World Forum for Harmonization of Vehicle Regulations**Working Party on Noise and Tyres****Seventy-ninth session**

Tyres: UN Regulation No. 117 (Tyre rolling resistance, rolling noise and wet grip)**Proposal for Supplement 16 to the 02 series of amendments
to UN Regulation No. 117****Submitted by the experts from the European Tyre and Rim Technical
Organization***

Figure 1
Nomenclature explanation related to grip index of the tyre

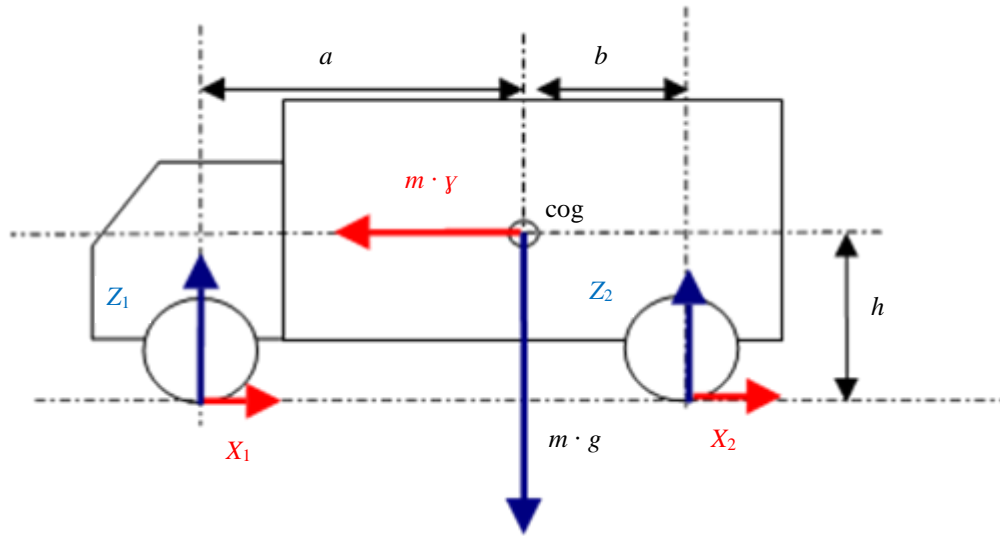
Paragraph 2.2.2.7.5., amend to read:

"2.2.2.7.5. Calculation of the relative wet grip index of the tyre

The wet grip index represents the relative performance of the candidate tyre compared to the reference tyre. The way to obtain it depends on the test configuration as defined in paragraph 2.2.2.2. of this Annex. The wet grip index G of the tyre is calculated as reported into Table 7:

Configuration C1: candidate tyres on both axles	$G = f \cdot \frac{BFC(T)}{BFC(R)}$
Configuration C2: candidate tyres on front axle and reference tyres on rear axle	$G = f \cdot \frac{BFC(T) \cdot [a + b + h \cdot BFC(R)] - a \cdot BFC(R)}{BFC(R) \cdot [b + h \cdot BFC(T)]}$
Configuration C3: reference tyres on front axle and candidate tyres on rear axle	$G = f \cdot \frac{BFC(T) \cdot [-a - b + h \cdot BFC(R)] + b \cdot BFC(R)}{BFC(R) \cdot [-a + h \cdot BFC(T)]}$

<i>For class C2 tyres</i>	
<i>SRTT16C</i>	
$f = 1$	
<i>For class C3 tyres</i>	
<i>SRTT19.5, SRTT22.5</i>	<i>SRTT19.5 siped, SRTT22.5 siped</i>
$f = 1$	$f = 1.04$

Where (see also Figure 1):

f : correction factor depending on used SRTT
